UPDATE OF LIST OF PLANNING APPLICATIONS TO BE DECIDED BY

Planning Application 2025/91279

Variation condition 2 (plans) on previous permission 2020/91746 for erection of extra care development providing 80 apartments with associated communal facilities and landscaped gardens

Land off, Kenmore Drive, Cleckheaton, BD19 3EJ

PROPOSED LOCATION OF SUBSTATION COMPOUND

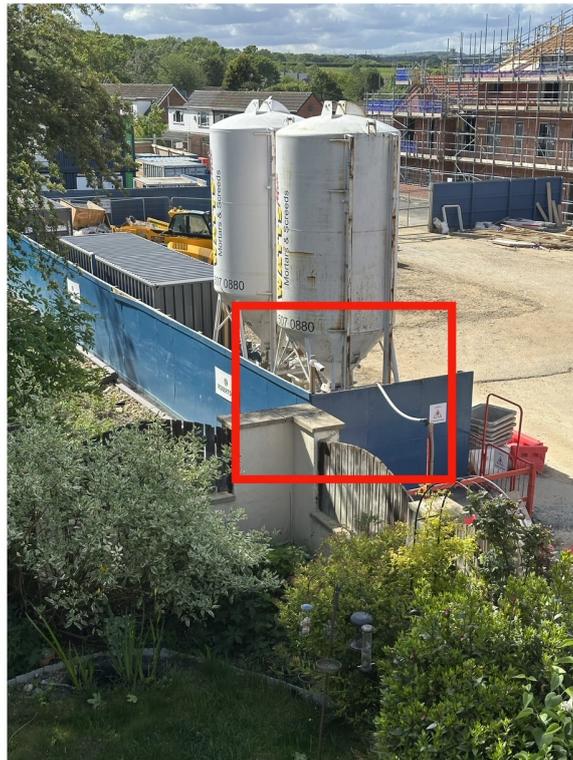
PHOTOGRAPHS SHOWING THE PROXIMITY OF THE PROPOSED SUBSTATION TO NSR1 REAR NORTH-WEST CORNER GARDEN BOUNDARY FROM WEST FACING BEDROOMS

The document includes photographs which show the relationship between the application site and 4 Coach House Paddocks, as well as annotation of the applicants submitted plans. Officers have assessed the impacts of the proposal on amenity in the published Committee Report and have no further commentary to add in respect of the submitted photographs and annotated plans.

CONCENTRATION OF SERVICE INFRASTRUCTURE

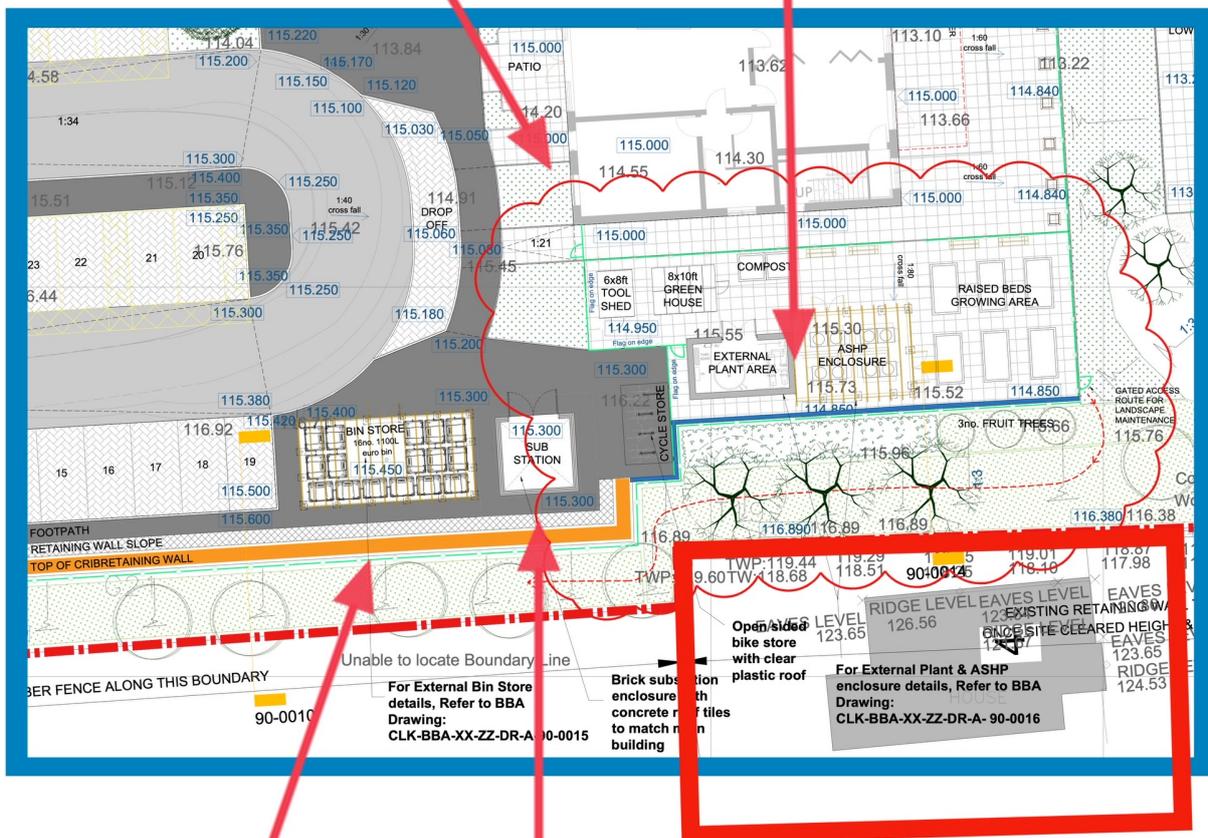
SITE SPANS 1.7 HECTARES WITH A 120-METRE SOUTHERN EDGE

KITCHEN EXTRACT FROM BISTRO

ASHP & PLANT ROOM COMPOUND

ELECTRIC SUBSTATION

REFLECTIVE CANYON EFFECT: AMPLIFIED NOISE AND RESONANCE AT EXISTING DWELLING (NSR1)

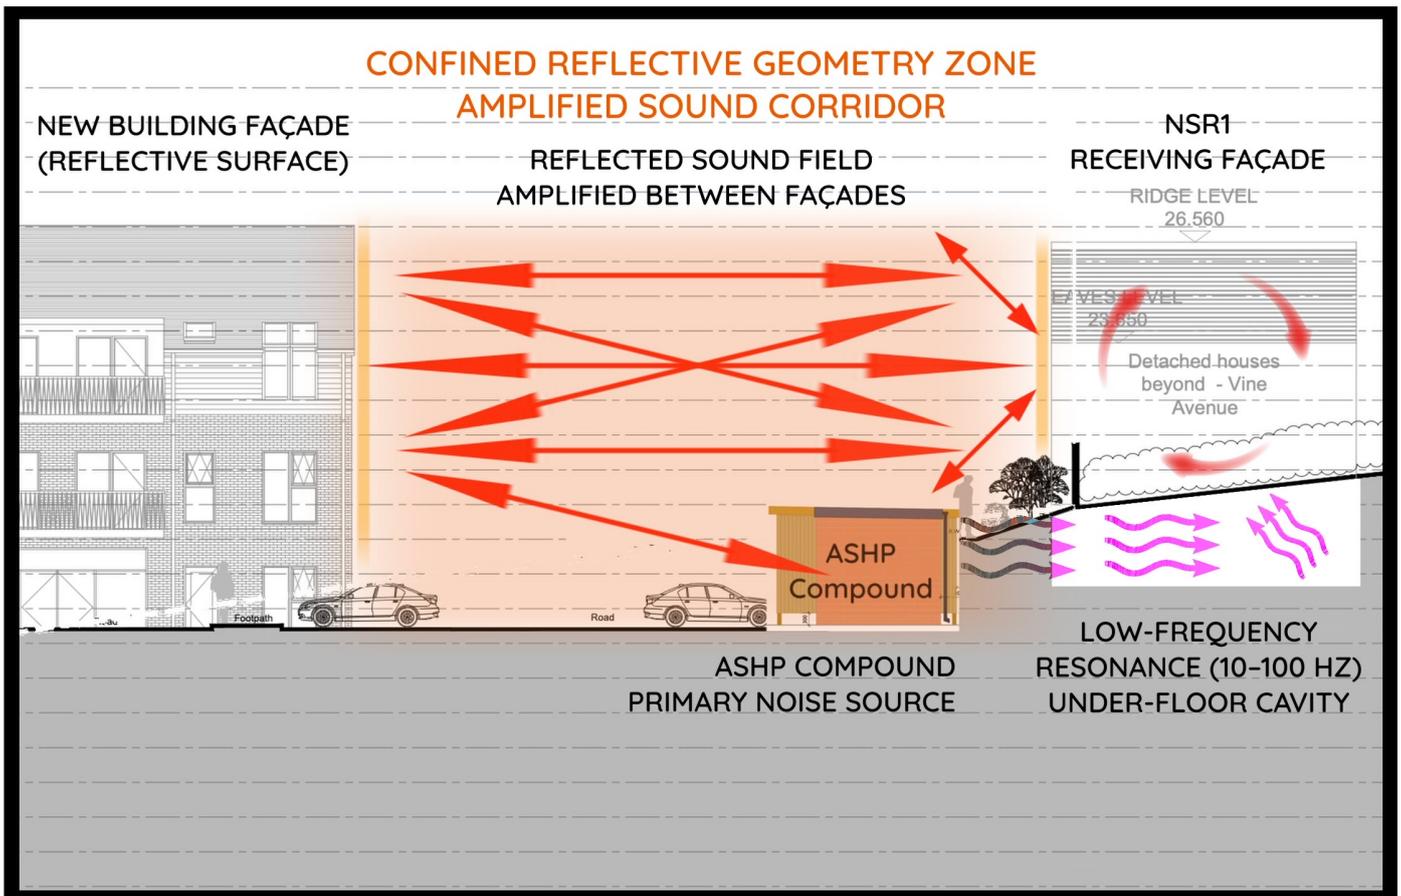
ILLUSTRATION SHOWING REFLECTIVE GEOMETRY AND LOW-FREQUENCY RESONANCE BETWEEN THE NEW BUILDING FAÇADE AND NSR1 (EXISTING DWELLING AT 4 COACH HOUSE PADDOCKS).

On page 5 of the document, the applicant has provided a diagram entitled "Reflective Canyon Effect: Amplified Noise and Resonance at Existing Dwelling (NSR1)". K.C Environmental Health have previously provided their comments on the acceptability of the scheme and as noted above, have no further commentary to add.

APPLICANT'S WITHDRAWN RELOCATION

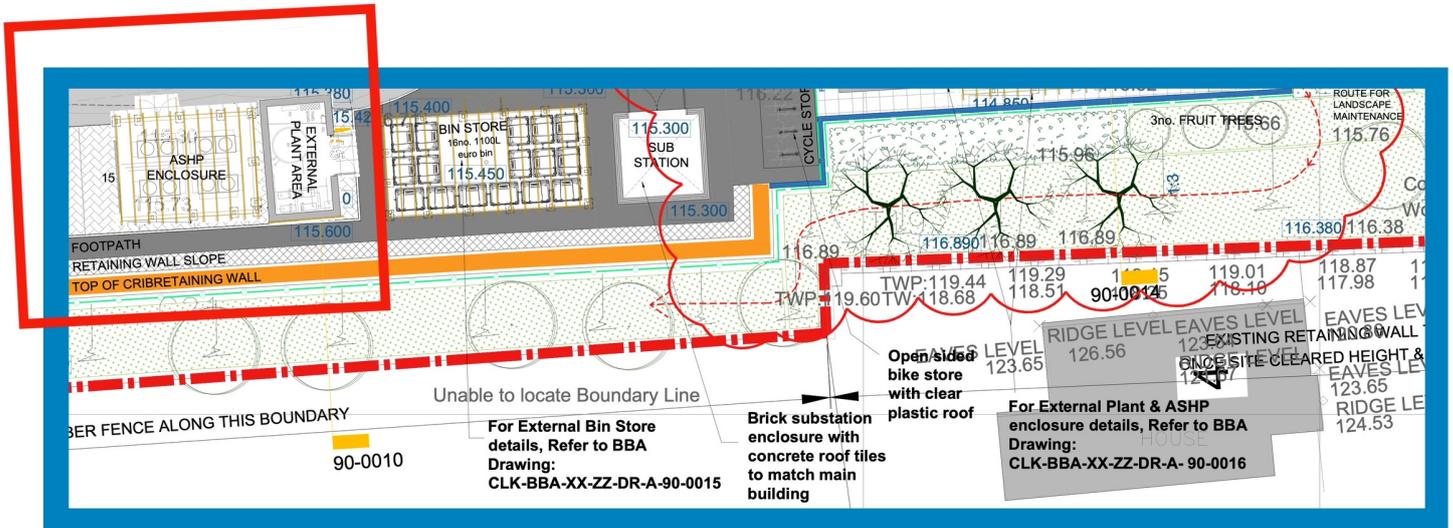
DIAGRAM SHOWING APPLICANT'S SUGGESTED RELOCATION BEFORE UNEXPLAINED WITHDRAWAL. DISTANCE 33M FROM NSR1

Part 6 of the document relates to a draft plan relating to a theoretical alternative location for the Air Source Heat Pump and associated structures. Since the plan was initially shared with officers, who in turn shared it with a local ward councillor, the applicant has confirmed that the document was provided in confidence and is not part of their submission. It therefore does not form a material consideration of this proposal. For the avoidance of doubt, it is not unusual for applicants to draft theoretical alternatives when considering options.

The committee report includes details of the assessment made for choosing the proposed location. Various potential locations for the equipment were explored and were ruled out. Ultimately the scheme as proposed has been assessed as acceptable in its location, giving due regard to various material planning considerations and careful consideration of noise.
